INSERTION INSTRUCTIONS FOR AMENDMENT 3 LETTERS 2 AND 3  
NRC QUESTIONS & RESPONSES

LIST OF EFFECTIVE PAGES  
NRC QUESTIONS AND RESPONSES  
 (Amendment 3, June 1979)

NUCLEAR REGULATORY COMMISSION QUESTIONS AND RESPONSES  
NEW HAVEN 1 AND 2

FIGURE Q3-2-1  
NATURAL DRAFT COOLING TOWER  
PERFORMANCE CURVES  
UNITS 1 & 2 - MODEL Z-11855  
NEW YORK STATE ELECTRIC & GAS CORPORATION  
ENVIRONMENTAL REPORT

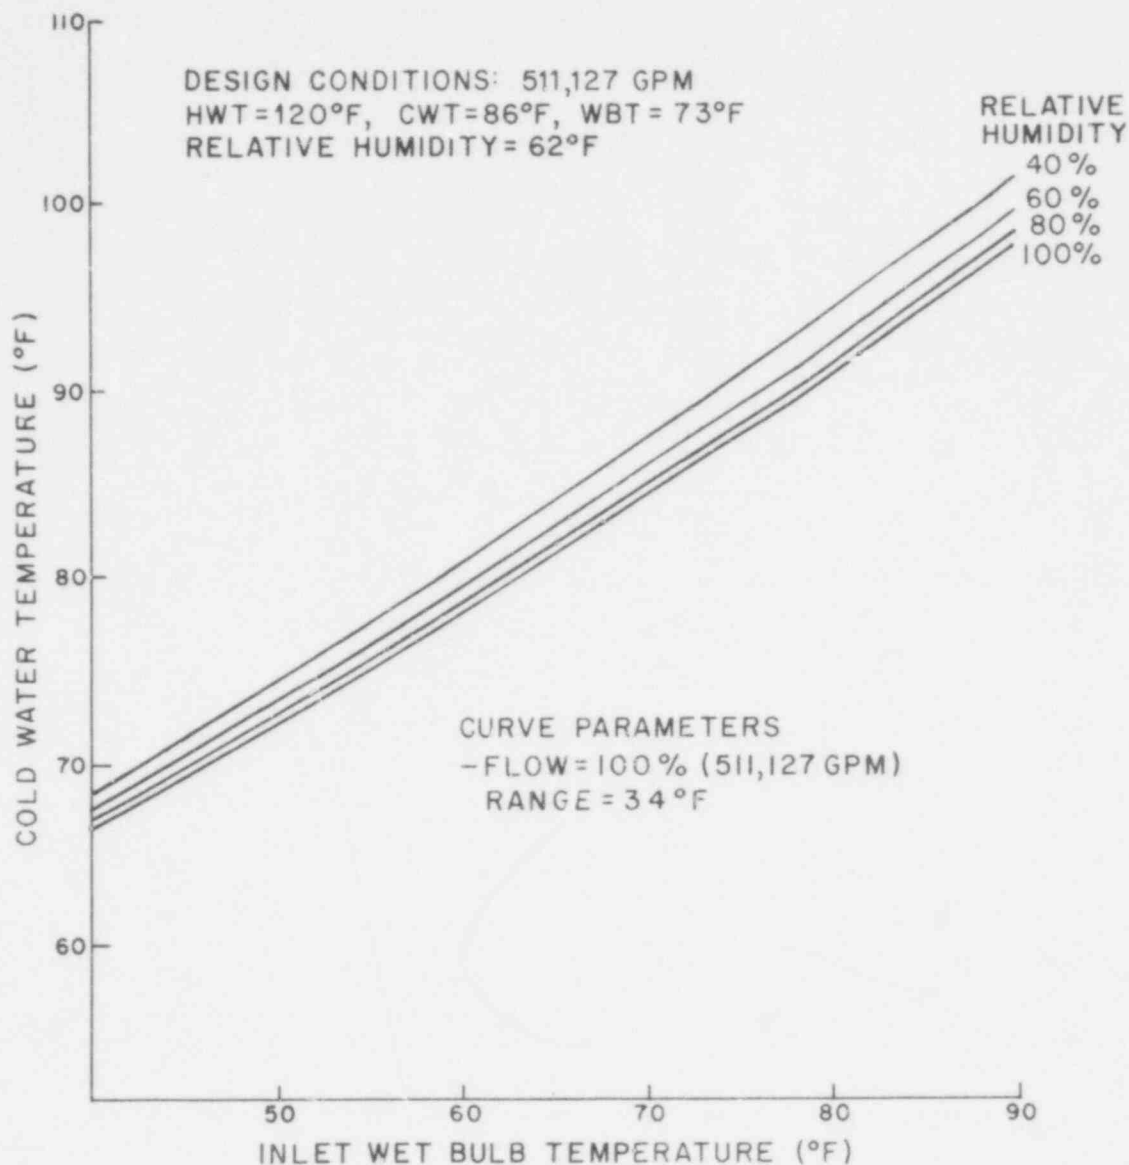
Provide the cooling tower design curve, i.e. the cold water temperature as a function of wet bulb temperature and relative humidity.

The engineering for the natural draft cooling towers has not been completed. Figure Q3-2-1 is an estimated design curve based on the design conditions of the circulating water system.

NCR 2150 RESOLUTION:

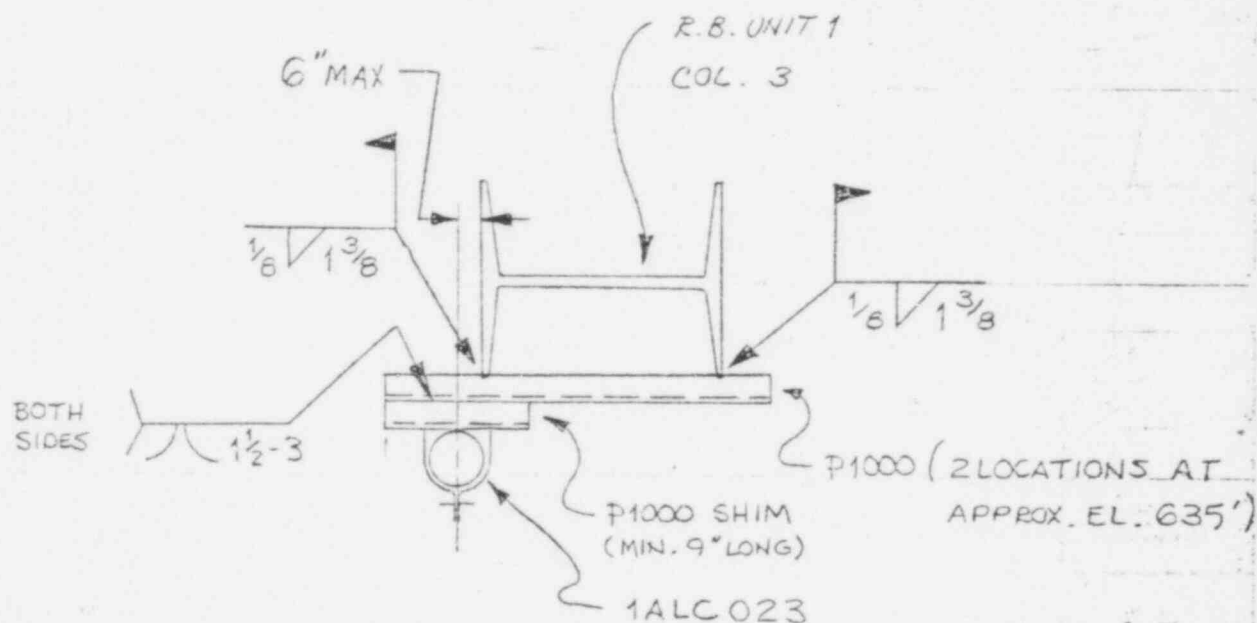
1. PROJECT NAME Midland			JOB NO. 07220			19. NO. 2150		20. PAGE 1 OF 2																							
2. UNIT(S) Cont. # 1		3. DRAWING/PART NO. E-656		REV 8		4. ITEM DESCRIPTION Conduit Support Supports		5. ITEM LOCATION Cont. #1 Col. 3, 635', ±																							
5. P.O. OR SPEC NO. N/A		7. SERIAL NO. N/A		8. REPLACEMENT PART P/N N/A REV N/A SER NO. N/A		9. SOURCE Construction		10. CONTRACTOR/SUPPLIER N/A																							
11. INSPECTION CRITERIA <input checked="" type="checkbox"/> DWG <input type="checkbox"/> SPEC <input type="checkbox"/> OTHER		18. NO. 1ALC023 NOE-42		12. ASME AUTHORIZED INSPECTION REQ'D <input type="checkbox"/> YES <input checked="" type="checkbox"/> NO		13. SKETCH ATTACHED <input checked="" type="checkbox"/> YES <input type="checkbox"/> NO		14. Discovered During <input type="checkbox"/> Rec'g <input checked="" type="checkbox"/> Const <input type="checkbox"/> Test		15. Equip Furnished By <input type="checkbox"/> Client <input type="checkbox"/> Eng <input checked="" type="checkbox"/> FLD																					
16. NONCONFORMING CONDITION: There is no approved detail for welding P1001 to the edge of the Flanges of Column #3 to be used as conduit supports, at Two (2) locations.						24. DISPOSITION CONCURRENCE

PROJECT ENGINEERING HAS REVIEWED AND EVALUATED THE NON-CONFORMING CONDITION AND FINDS IT UNACCEPTABLE AS-BUILT. PROJECT ENGINEERING RECOMMENDS THE SUPPORTS BE REWORKED AS SUPPORT TYPE 550, DWG. E-42, SH. 550.
